STAFF REPORT

PLANNING COMMISSION
DATE: 7/22/2024

AGENDA ITEM: PUBLIC HEARING - Preliminary Plat/Open Space Planned Unit Development request, Highpointe Crossing by Rachel Development

Rachel Development is requesting Preliminary Plat and Open Space Planned Unit Development (OP-PUD) approval for a 65-unit development on approximately 78 acres of land. The project is to be called Highpointe Crossing and is located west of Inwood Avenue North between the existing Torre Pines and Lake Elmo Heights subdivisions. The developer is requesting flexibility from the Rural Residential zoning regulations to allow for an Open Space development.

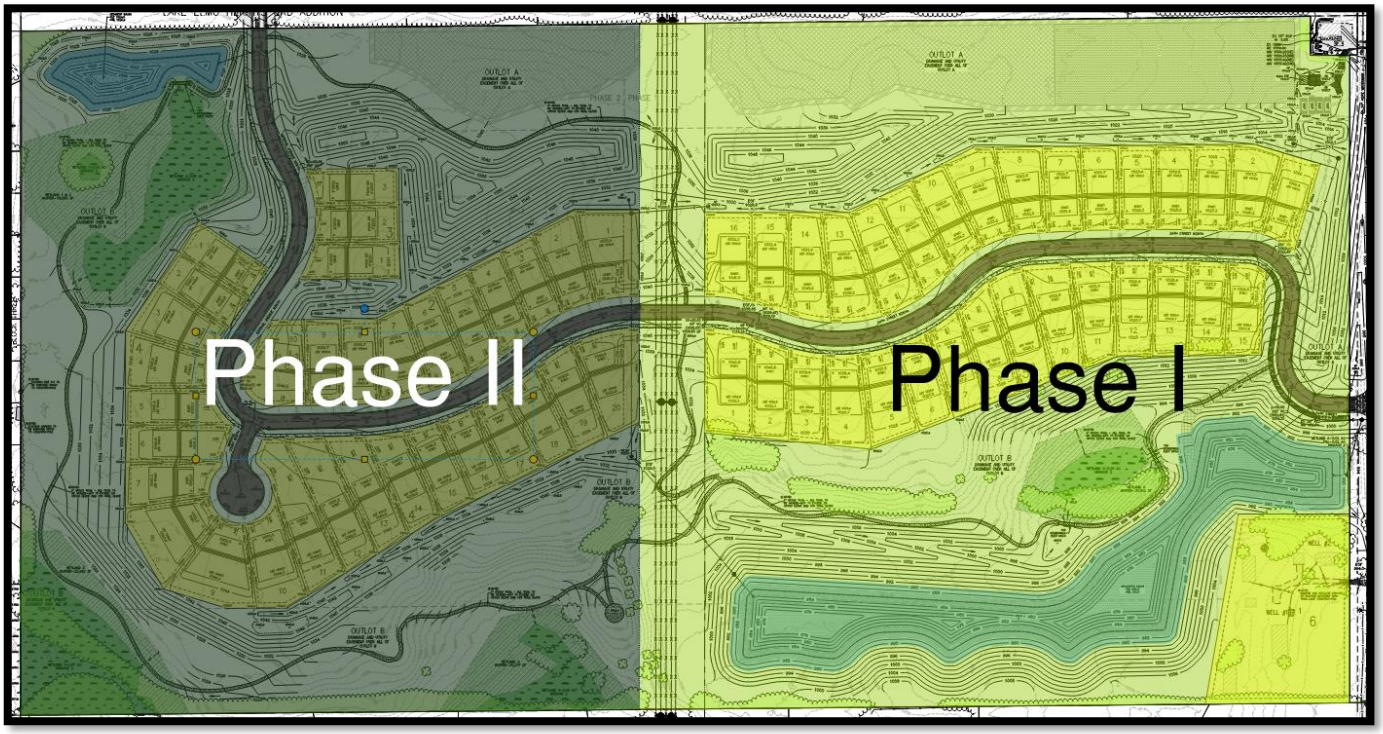
- The Phasing Plan must include a temporary cul-de-sac consistent with City design standards at the end of the Phase 1 street. Add City detail 807B (temporary cul-de-sac) to the Preliminary Plan detail sheets.

STREET TREE PLANT LIST/SHEETS 6.00, 6.01, 6.02 & 6.03

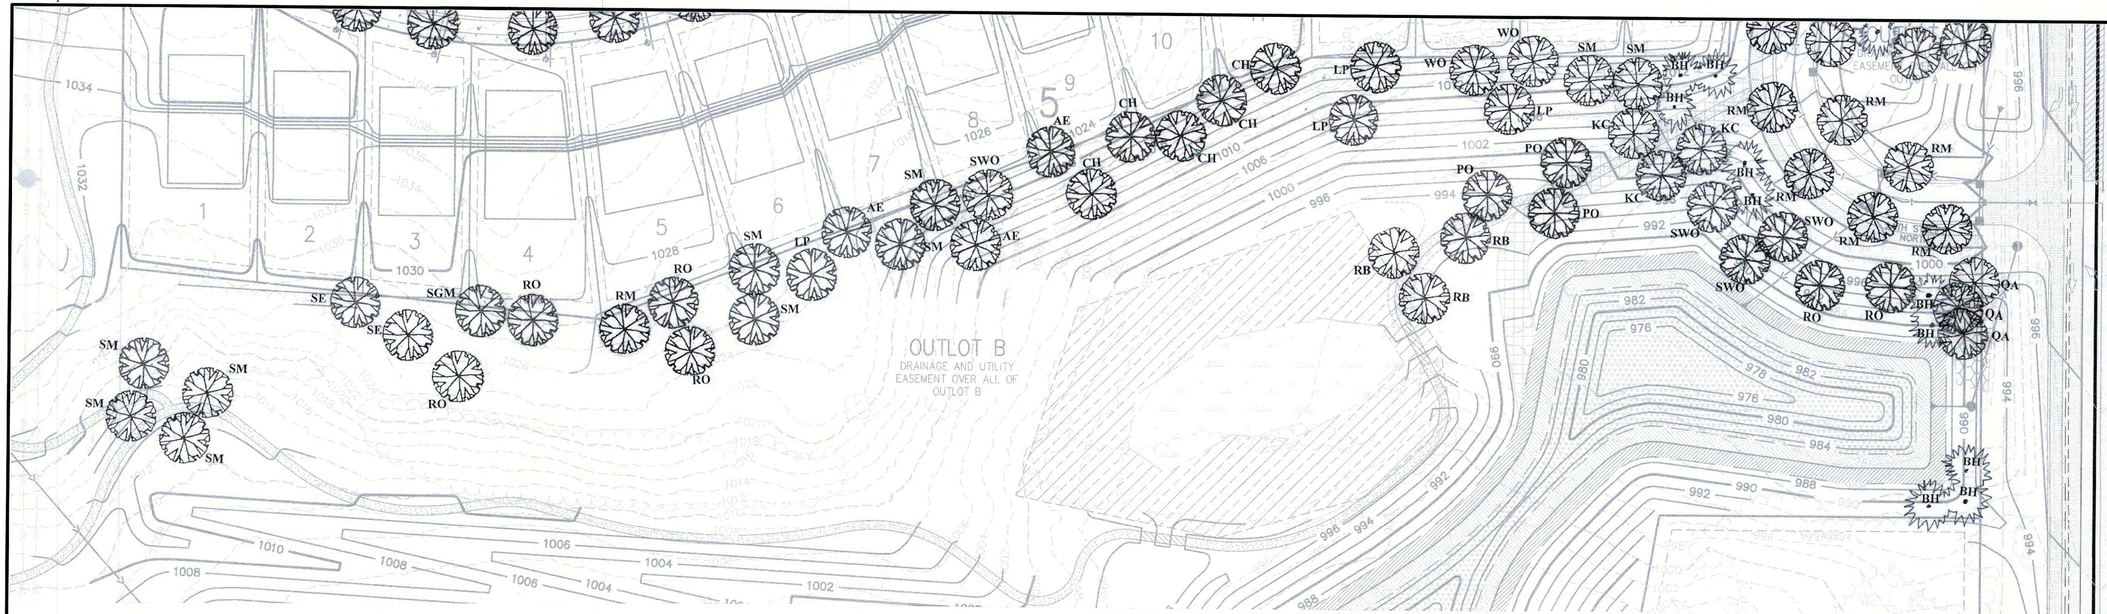
d. Landscaping Standards – A total of 10 trees per lot and one boulevard tree located every 30 feet is required. The Applicant's plan only provides 5 trees per lot and one boulevard for every 50 feet. Staff suggest that the applicant revise the plan to conform with the City's planting requirements. **Deviation requested**.

Landscaping. As described in the above section on Development Standards for OP PUDs, the developer is proposing not to provide all trees required in LEC 105.12.1060. This is broken down as follows:

b. The Plans must demonstrate at least 400 tree plantings in the development, as approved by the City's Landscape Architect, meeting the boulevard spacing requirements in City Code.

CONCEPT - PROPOSED MONUMENT SIGN
HIGHPOINTE CROSSING

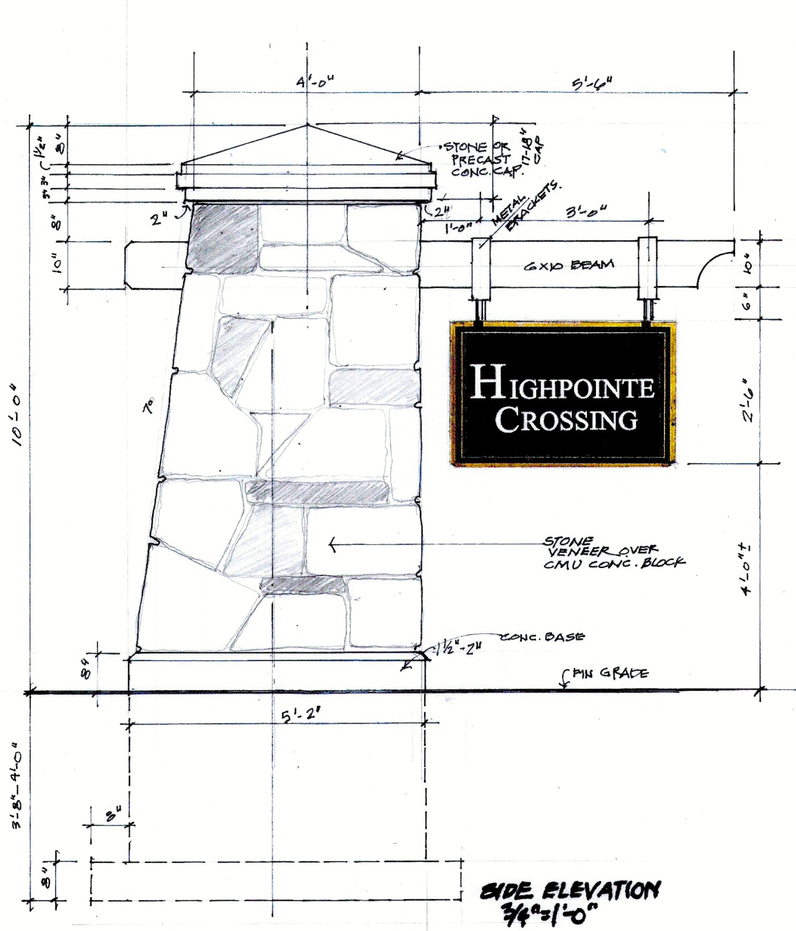
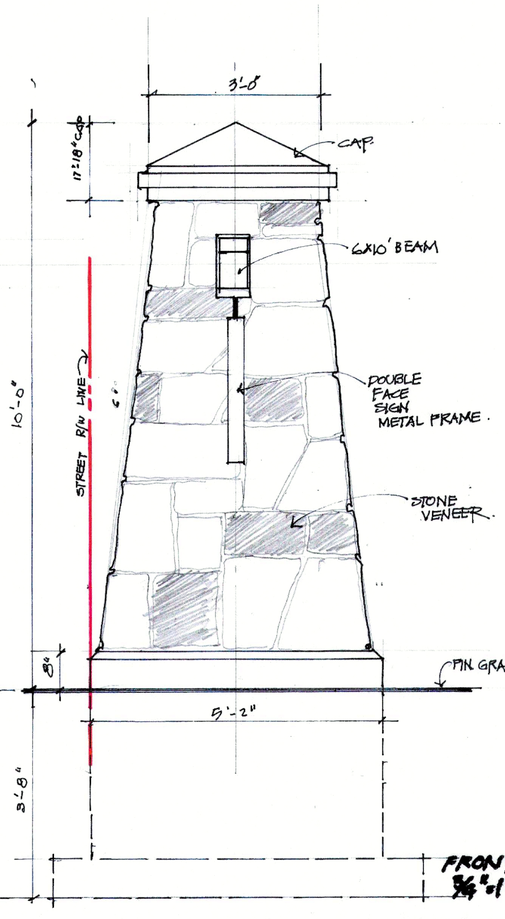
Subdivision Signs. Section 105.12.430 allows one (1) subdivision sign for this residential development with a maximum sign area of 32 sq. ft. One sign is proposed within the 10-foot setback for such signage. There does not appear to be a rationale for deviations to the signage requirements. A condition of approval has been added that the signage is relocated and ultimately conforms with City Code.

2. The Plans must be revised as follows to address Planning Comments in the Staff Report dated July 22, 2024:
   a. The Plans must demonstrate conformance with applicable City Code requirements for trails, and subdivision monument signs in OP PUDs.
